Field campaign

Topic	TPMS Warning Lamp on DIP Bentayga Series 25MY (SC25/25)
Market area	Bentley: worldwide (2WBE),China 796 VW Import Comp. Ltd (Vico), Beijing (6796)
Brand	Bentley
Transaction No.	2077570/1
Campaign number	ED41
Note	
Type	
US code

Bentayga Series 25 Model Year

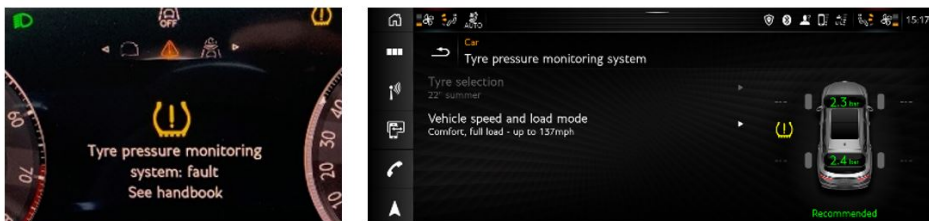
The following Tyre Pressure Monitoring System (TPMS) warning lamps can show on DIP following replacement of the wheel assemblies. Either a partial active warning or fault warning will be shown. Example below:

The tyre pressure monitoring system fails to learn and display actual pressure values when the wheel assemblies are replaced. The Tyre Pressure Monitoring Control unit retains the sensor IDs as per original built conditions and the wheel position. This is until the unit is introduced to GEN4 car set of wheel sensors / assemblies which resolves the fault.

Replace the fitted TPMS sensors to Gen 4 level on each wheel.

The TPMS ECU starts learning new GEN4 sensors automatically in the background and displays correct pressure values within 10 minutes of drive cycle when vehicle speed is more than 15Km/h.

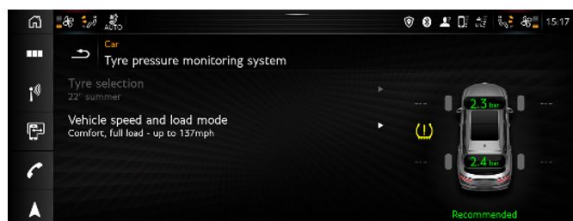
The following Tyre Pressure Monitoring System (TPMS) warning lamps can show on DIP following replacement of the wheel assemblies. Either a partial active warning or fault warning will be shown. Example below:

The tyre pressure monitoring system fails to learn and display actual pressure values when the wheel assemblies are replaced. The Tyre Pressure Monitoring Control unit retains the sensor IDs as per original built conditions and the wheel position. This is until the unit is introduced to GEN4 car set of wheel sensors / assemblies which resolves the fault.

Refer to ElsaPro Repair Group 44 – 'wheel electronics replace'

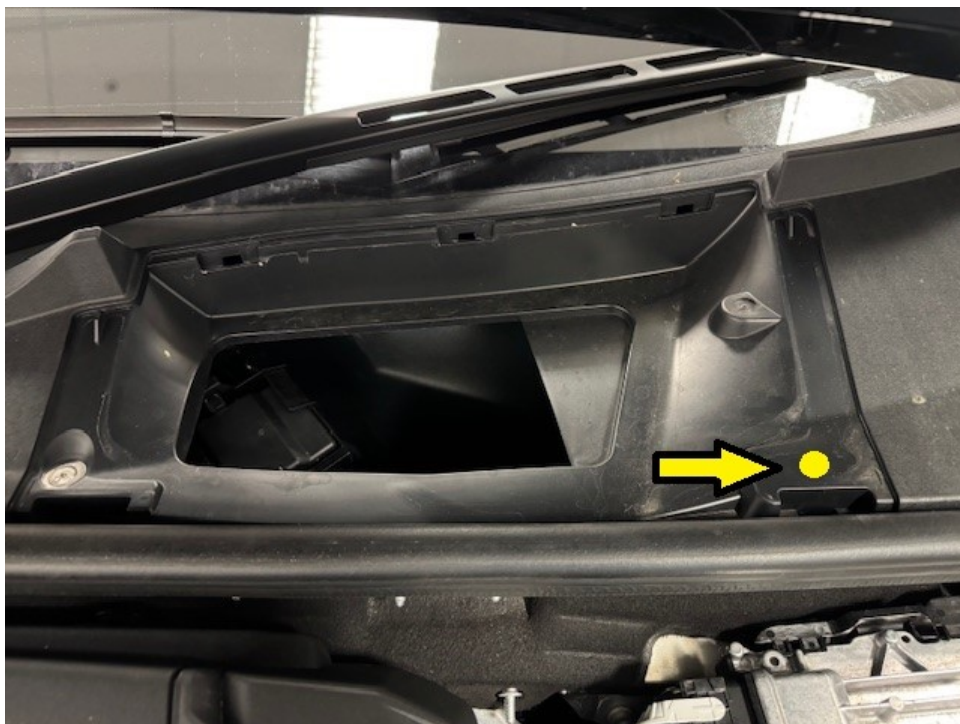
Follow the instructions below for a TPMS replacement

Once the TPMS has been replaced, the TPMS ECU starts learning new GEN4 sensors automatically in the background and displays correct

pressure values within 10 minutes of drive cycle when vehicle speed is more than 15Km/h.
